PRAIRIE ISLAND NUCLEAR GENERATING PLANT
Docket Nos. 50-282 License Nos. DPR-42
50-306 DPR-60

Additional Information Related to Station Electric
Distribution System Voltage Study

Response to Request for Additional Information
Prairie Island Nuclear Generating Plant, Units 1 and 2
June 2, 1982

Figure 1 Bus Configuration With Completion of 2R Installation

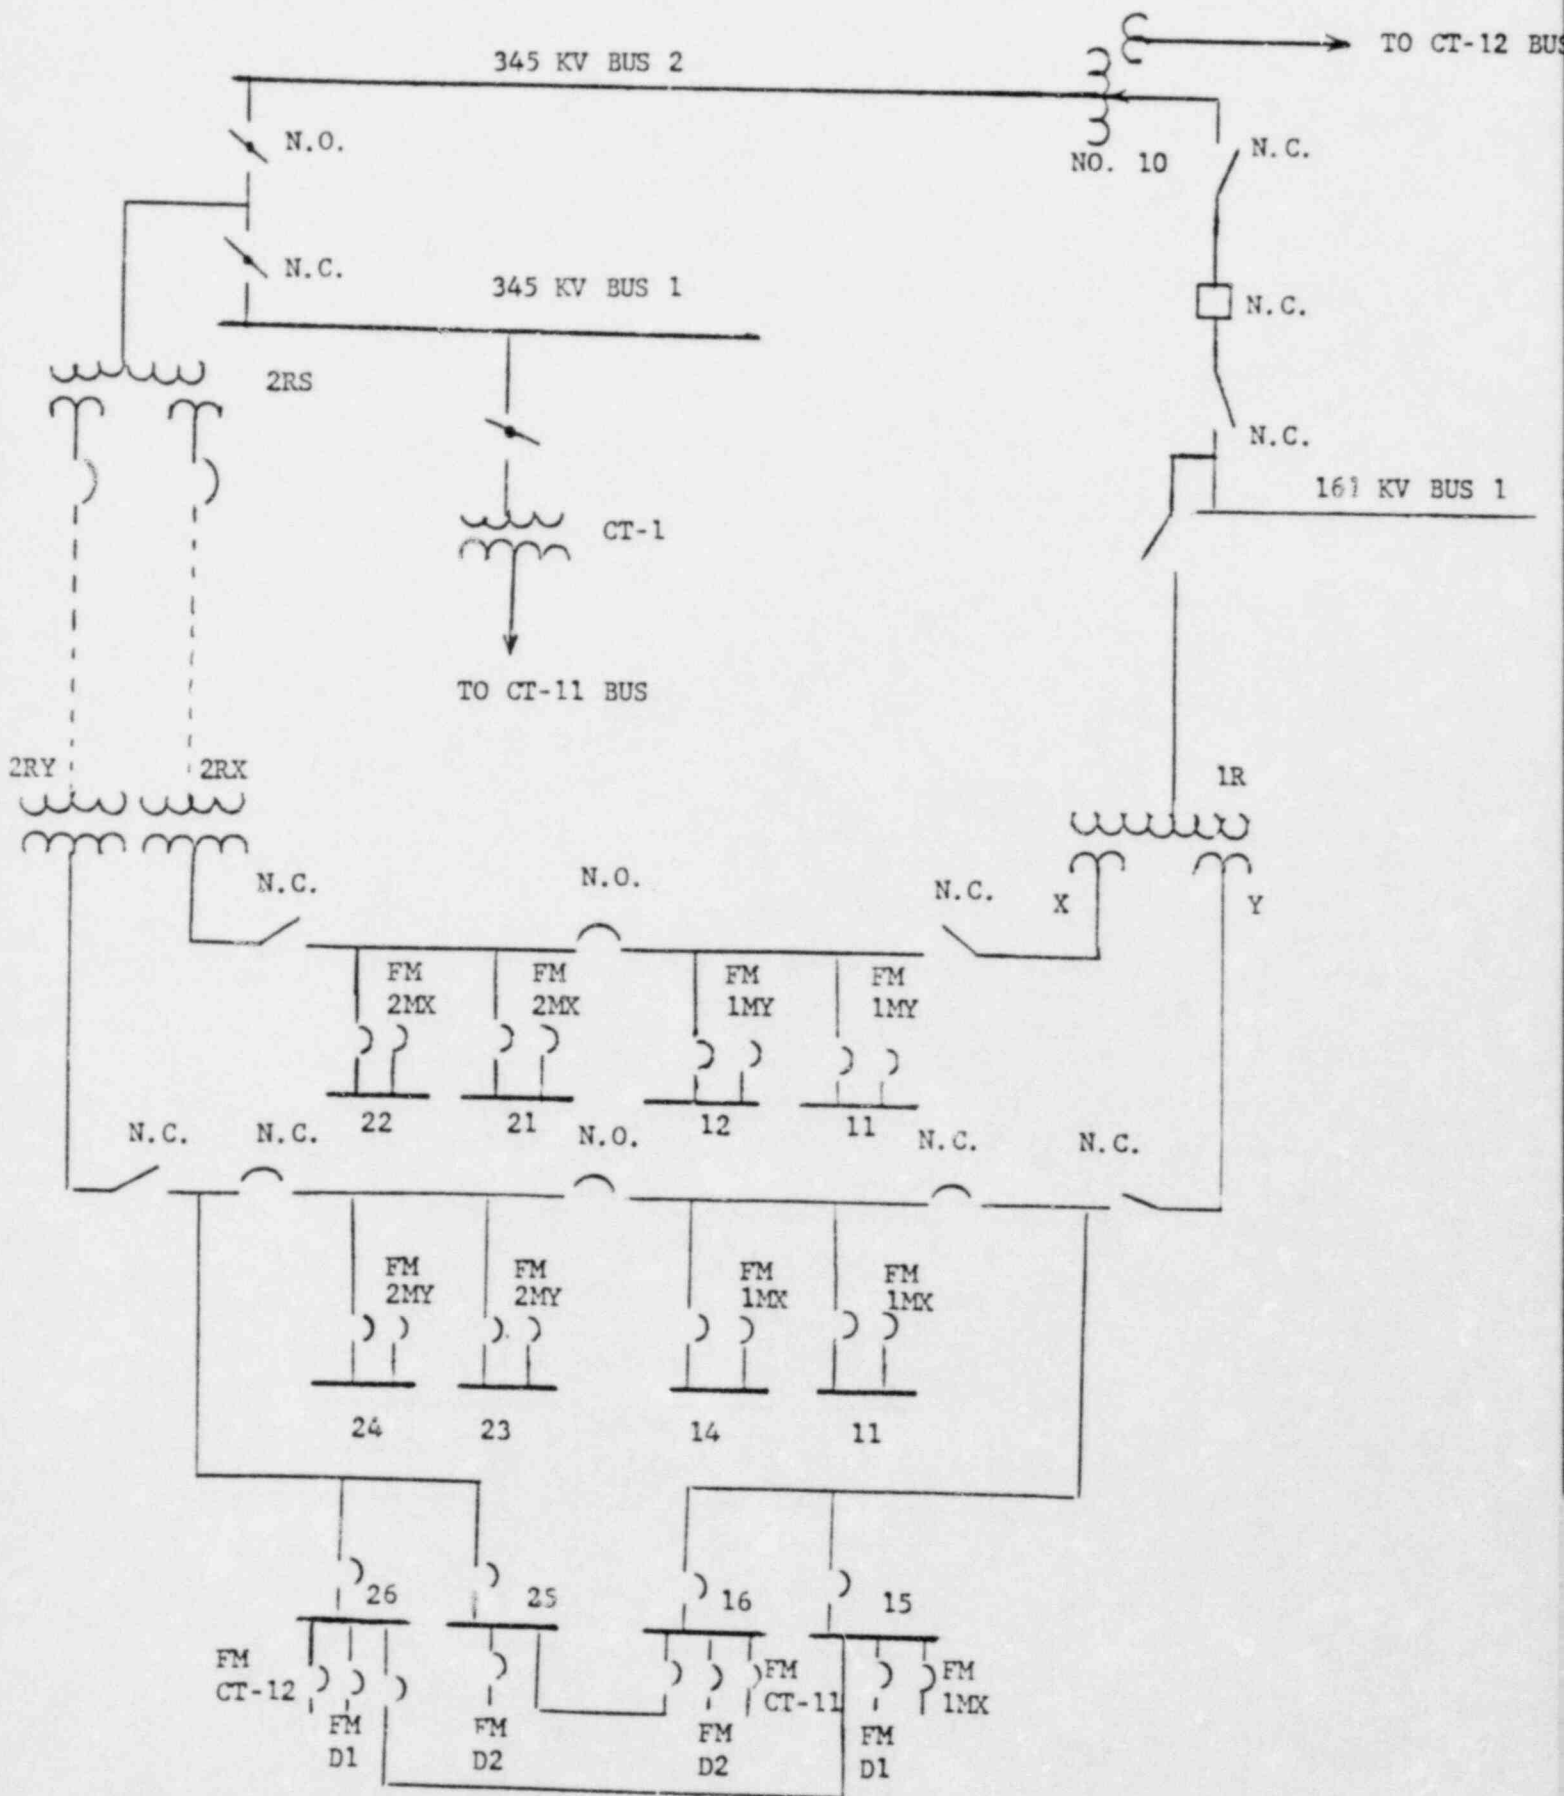
1. Please submit a one-line diagram showing the feeders for transformer 2R and the buses it is energizing.

See attached Figure 1.

Figure 2 Interposing Relay (IR) Circuit

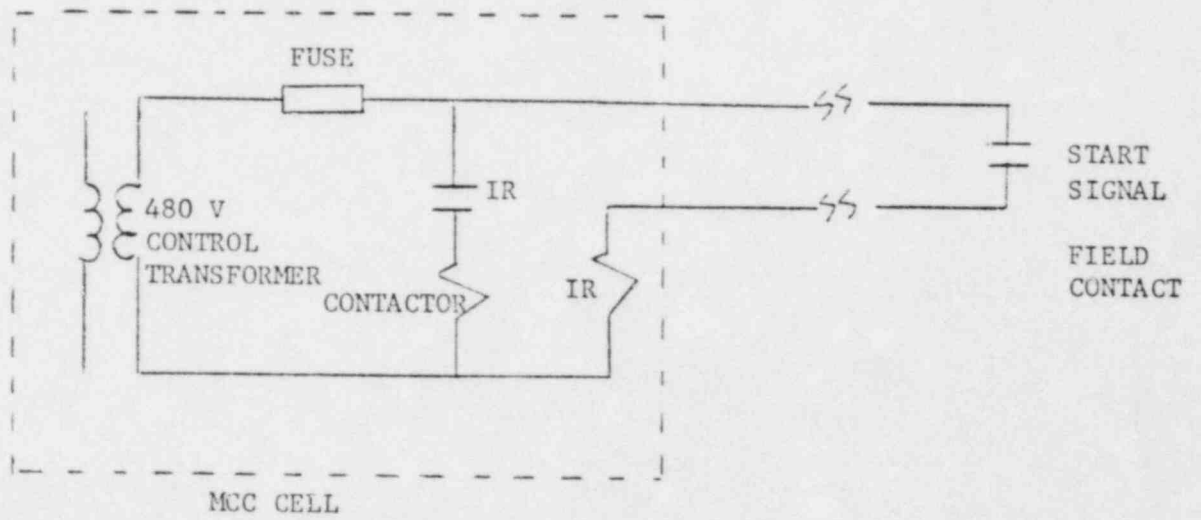
5. Ref. 2 refers to the use of Interposing relays. Please expand on how the interposing relays function in the circuitry.

Refer to Figure 2. The interposing relay reduces the current (and resulting losses) in control wiring.

Figure 3 Fan Coil Unit Performance Data

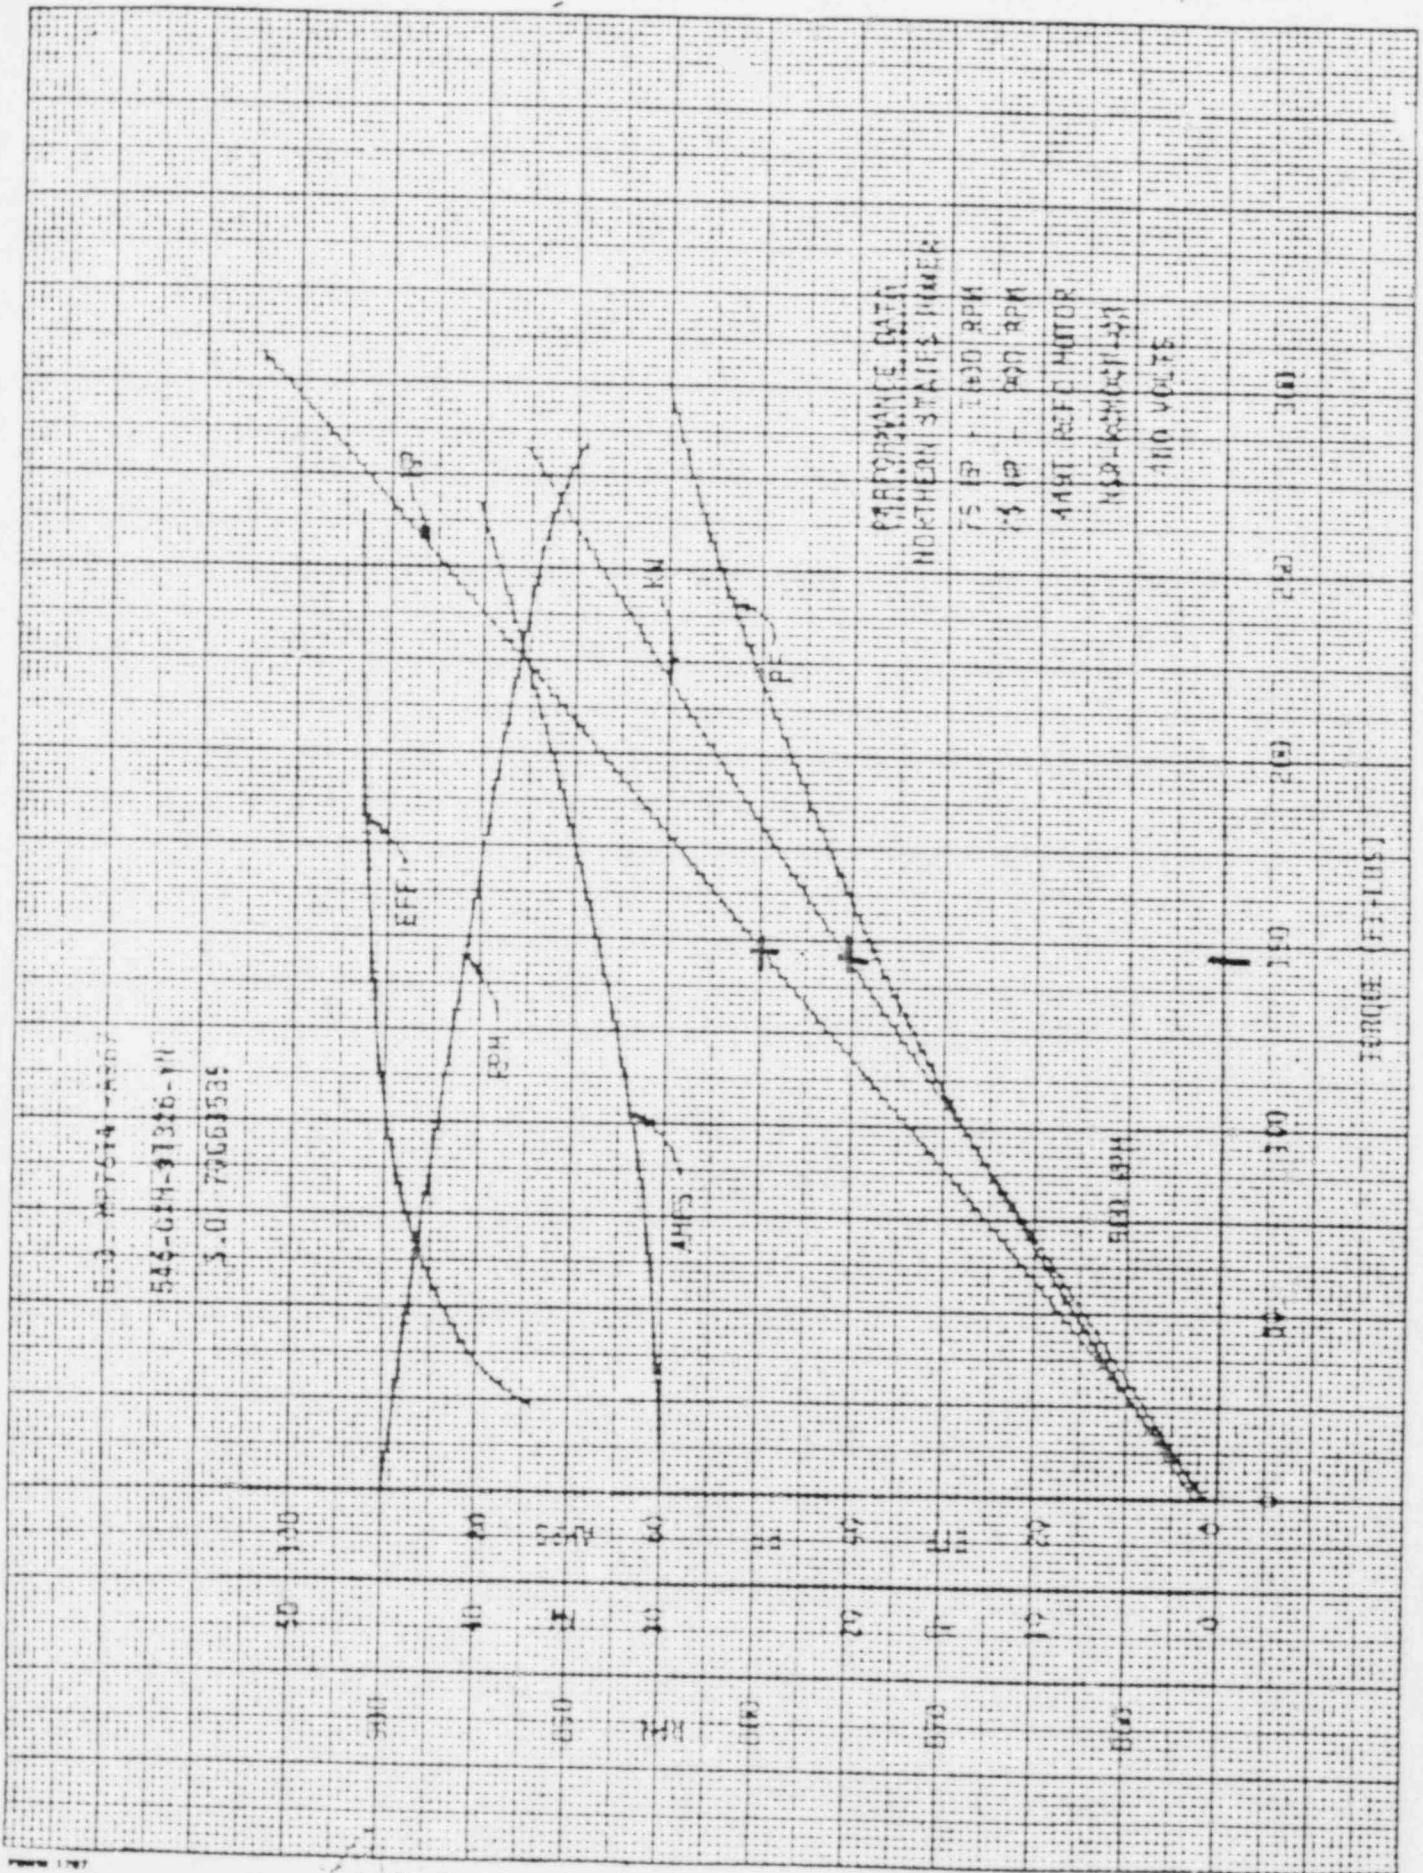
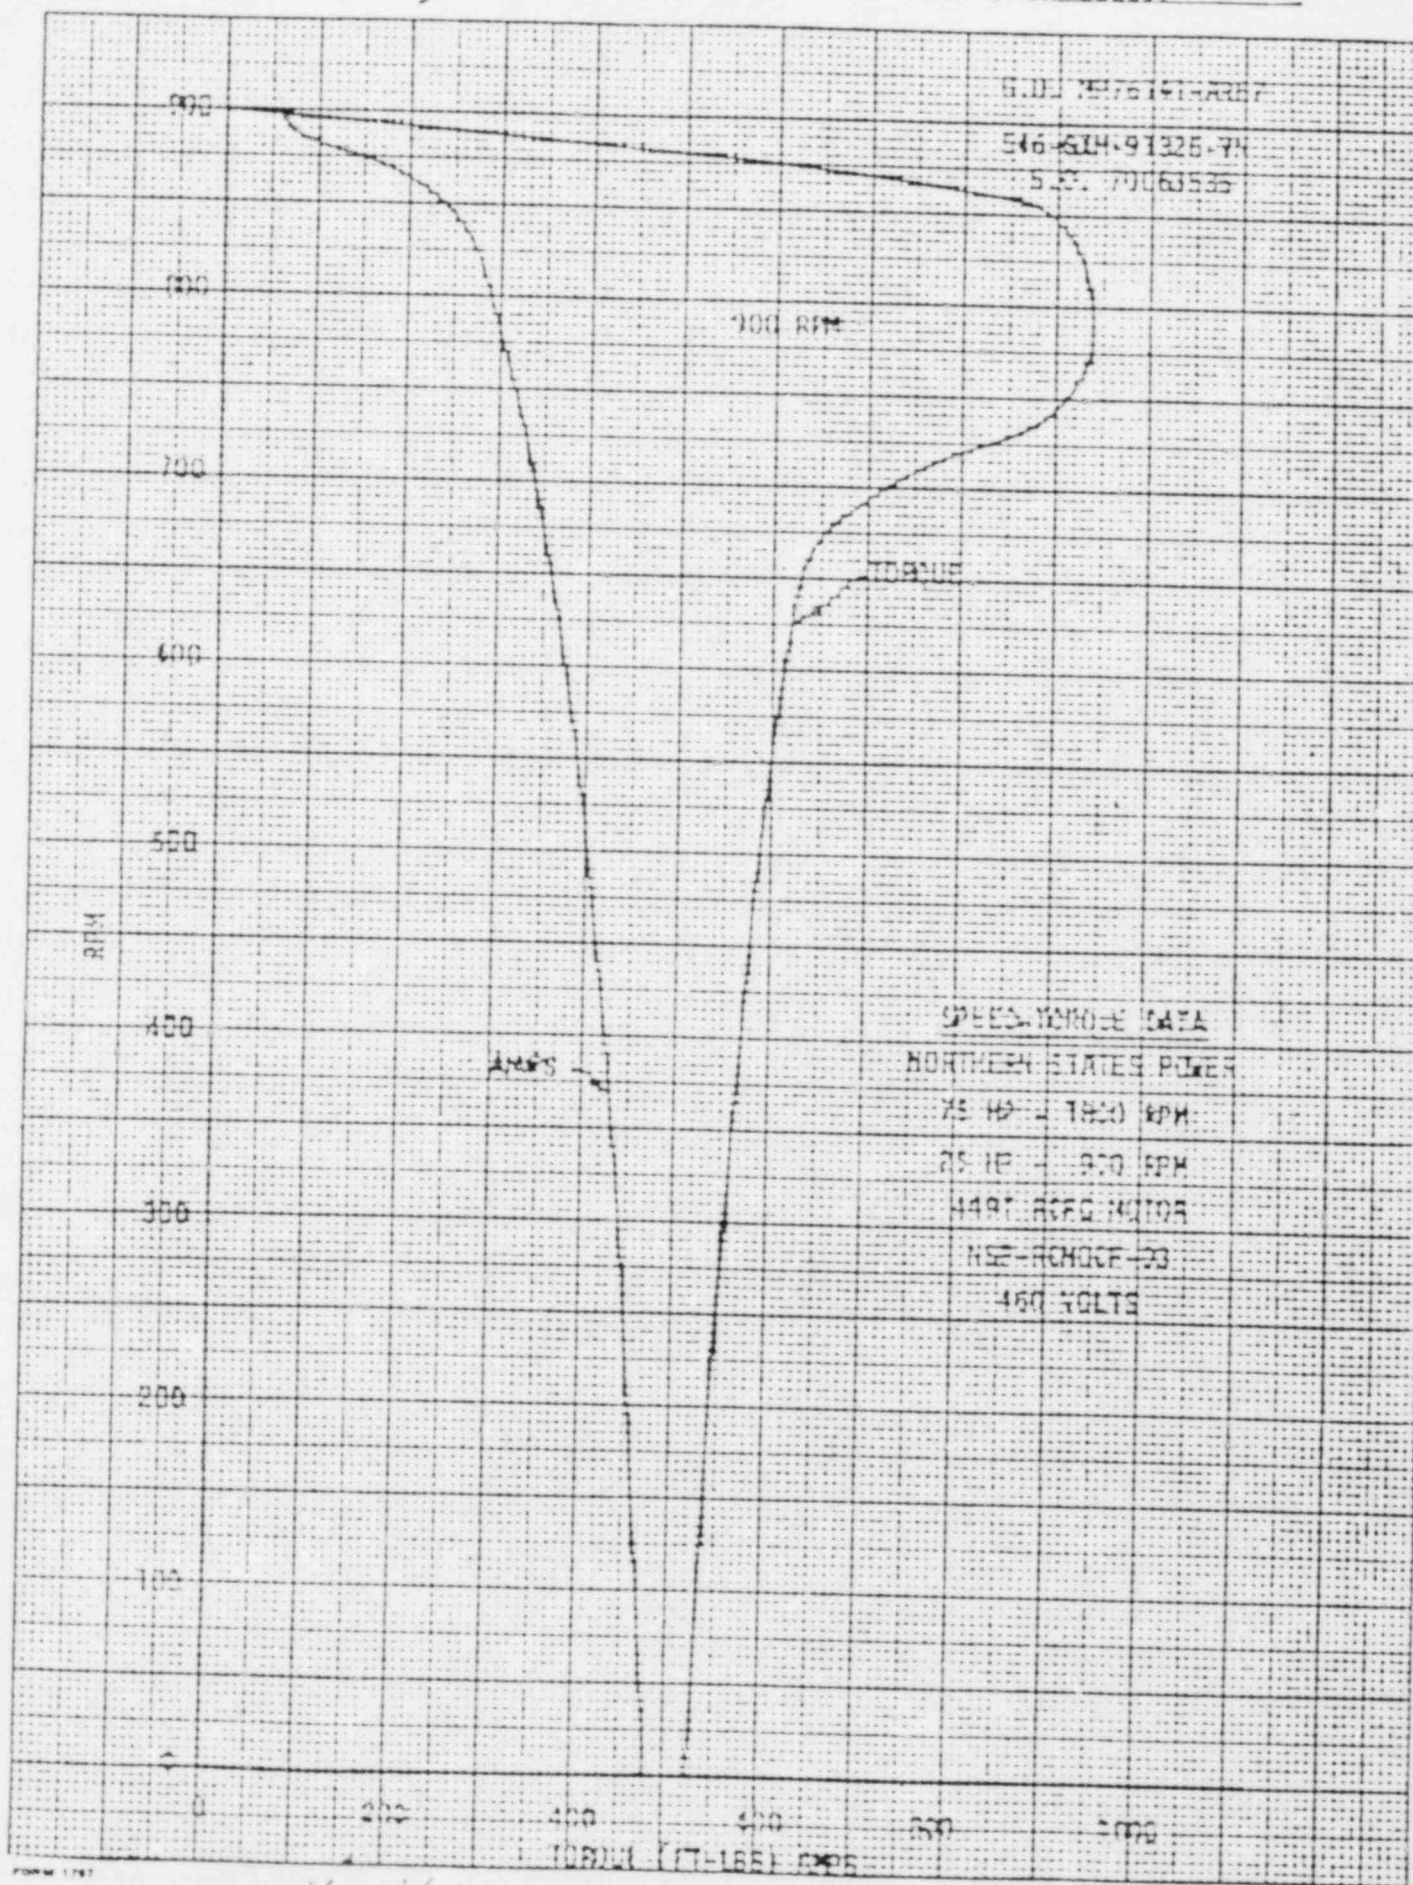
4. The analysis of Ref. 2, Table 11 indicates that some 480-volt motors could be starting at 73% of nameplate voltage. Have tests been conducted to show that these motors will start at the degraded value? Provide the results of these tests or provide the manufacturer's motor curves. What is the service factor of the motors that will be operated below nameplate rating? Table 11 also indicates that the voltages could drop to 70% of 480 volts on bus 120. Page 2 of Rev. 4 states that the maximum drop out voltage for motor starters is 340 volts or 71% of 480 volts. Verify that this difference will not cause the possibility of a motor starter spuriously dropping out.

The Compressor and CR Chiller are unloaded during starting. The FCU has a maximum accident load of 25 HP or 150 ft-lbs. The FCU motor has breakdown torque of 900 Ft-lbs. Based on starting circuit design and manufacture's data, these are capable of starting with 50% voltage. Refer to the attached data sheet and curves.
